**Title: New Construction, Proposed Vertical Alignment at Existing Bridge File (BF) Location**

Memorandum (or Approval) Date: September 7, 2012  
 Design Exception Request Date: August 29, 2012  
 Region: Peace  
 Approval Status: Approved

Project Location					
Highway	Control Section	At km	From km	To km	Existing AADT
88	12	46.3			180

Photograph/Diagram

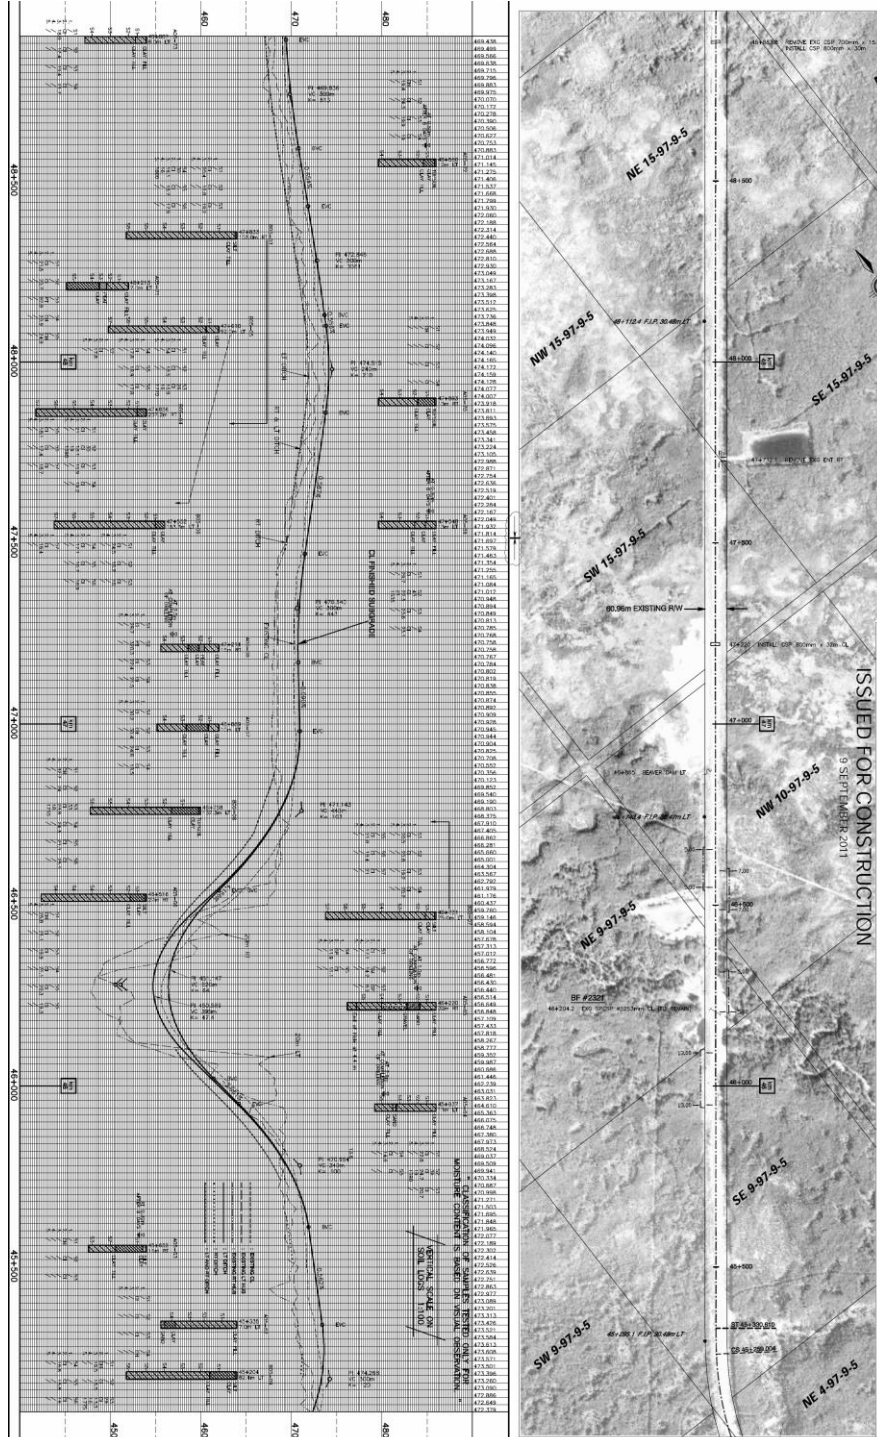
The following design exception request is for the following:  
 Proposed existing sag curve K value of 47.4 is located at BF2321. Based the ATHGDG, Chapter B – .4.4 Vertical Curves, the minimum sag K value is 60 for headlight control.

- Existing BF2321 is an 5250mm SPCSP. The proposed sag curve would be improved to new construction as part of the BF replacement. The BF would need to be replaced in approximately 14 years.
- Improving the K sag curve to minimum K 60 would include removal of the existing collar on both ends and extending the existing BF approximately 27m in total is not considered economical due to the estimated cost and service life remaining.
- Collision history for the five year period from 2006 to 2010: No reported collisions within 1 km of Km 46.3.
- Existing and 20 year projected AADT are low, 180 and 288 vpd respectively.

Embankment protected with longitudinal barrier with crashworthy end treatments.
